FIELD SERVICE BULLETIN

FSB Number: BJCCFSB2005-342
Author: Zhong YJ;
Date: 21th .Nov. 2005
Total No. Of Pages: 3
Subject: V3C RUIM-Heathrow Keypad Peel Off Issue
Model Affected: V3C RUIM-Heathrow (CDMA RUIM PRC Only)
Level of Repair: Level 2

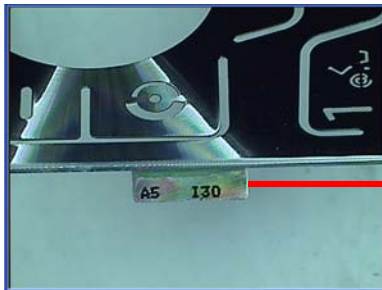
This issue has been identified during the V3C RUIM NPI returns, the customer complained "Main Keypad, wear", the symptom is "2" key peel off. Root causes are following: the adhesion between top coating and metal substrate is partially not formed appropriately due to the high humidity and low temperature; The original humidifier at top coating line has lack of capacity and it was out of control limit of the humidity; Especially at night time working, humidity is higher than the day time and it can deteriorate the adhesion characteristics. Please see the picture.

1. To tightly control the humidity, new dehumidifier is installed additionally at the top coating line ;
2. Control temp/humidity tightly as 22 -27C and below 60% for process control margin;
3. Cross cut test is added as in-line testing after top coating process (2 pcs sampling every 300 pcs)

Improvement part
date code location

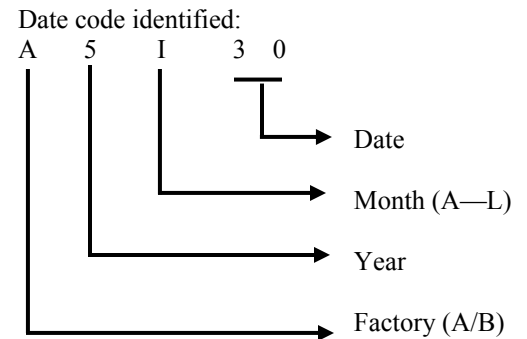
Improvement part D/C is after Sep.30.05 and marked on the side.

Keypad P/N: 37-82000-01
